PEACH BOTTOM ATOMIC POWER STATION, UNIT NO. 3

AMENDMENT TO FACILITY OPERATING LICENSE

Amendment No. 85
License No. DPR-56

ATTACHMENT TO LICENSE AMENDMENT NO. 85

FIGURE 3.5.K.1 MCPR OPERATING LIMIT vs T

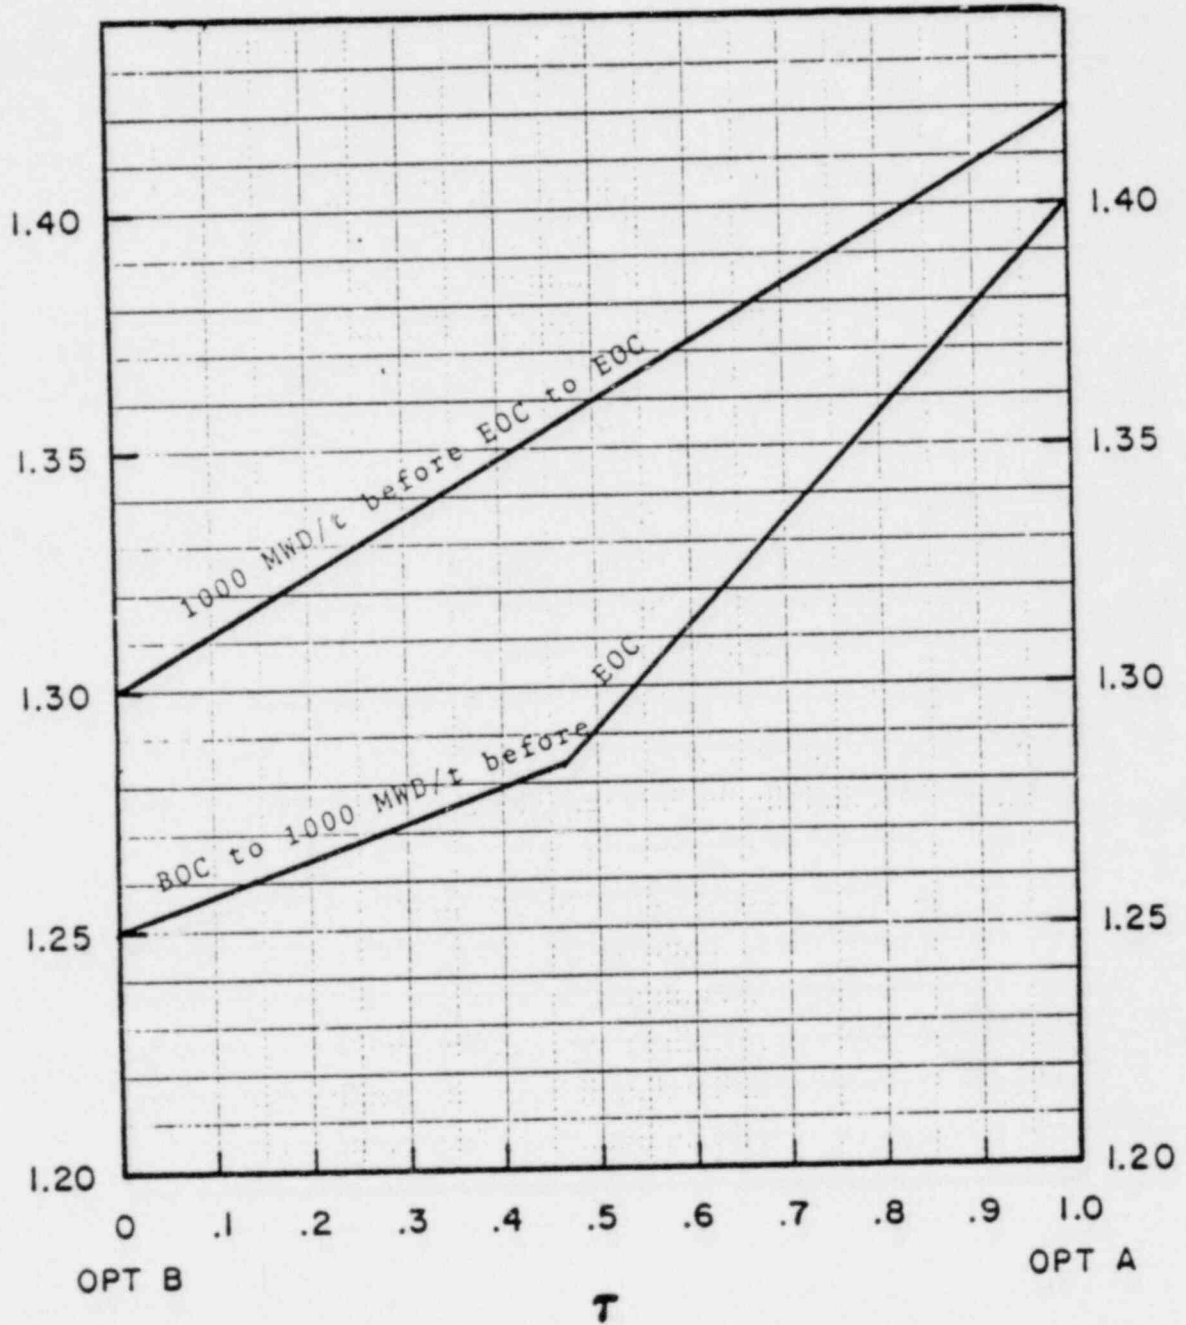
Replace the following pages of the Appendix "A" Technical Specifications with the enclosed pages. The revised pages are identified by Amendment number and contain vertical lines indicating the area of change.
